MATERIAL		FINISH		NEXT ASSY		PART NAME		REV.	
N/A		N/A μinch		D1102361		ALIGO TMS F2 MIRROR ASSEMBLY		v5	
LIGO CALIFORNIA INSTITUTE OF TECHNOLOGY MASSACHUSETTS INSTITUTE OF TECHNOLOGY				SYSTEM ADVANCED LIGO SUB-SYSTEM AOS		DESIGNER C. CONLEY 17 SEP 2010 DRAFTER E.SANCHEZ 29 MAR 2012 CHECKER SEE DCC APPROVAL SEE DCC		SIZE DWG. NO. B D1200243 SCALE: 1:2 PROJECTION:	
SHEET 1 OF 1

D1200243 ALIGO TMS F2 Mirror Assembly, PART PDM REV: X-016, DRAWING PDM REV: X-001

DETAIL B  
SCALE 1 : 1

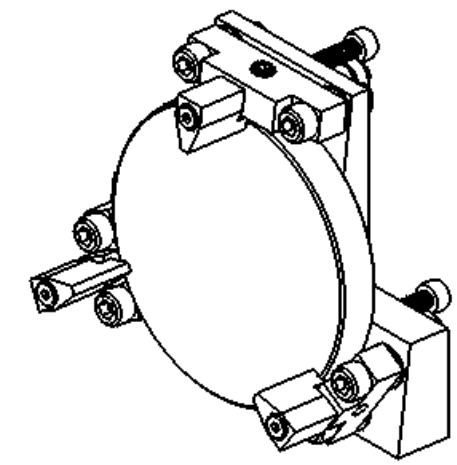
UPDATE TO CURRENT VERSION

THIS SCREW IS REPLACED WITH THE ABOVE TRUSS HEAD THIS WILL PROVIDE MORE ENGAGEMENT WITH THE SCREW ASSEMBLY FOR SECURE HOLD DOWN

TRUSS HEAD SLOTTED MACHINE SCREW

91785A247 #10-24 X 1"
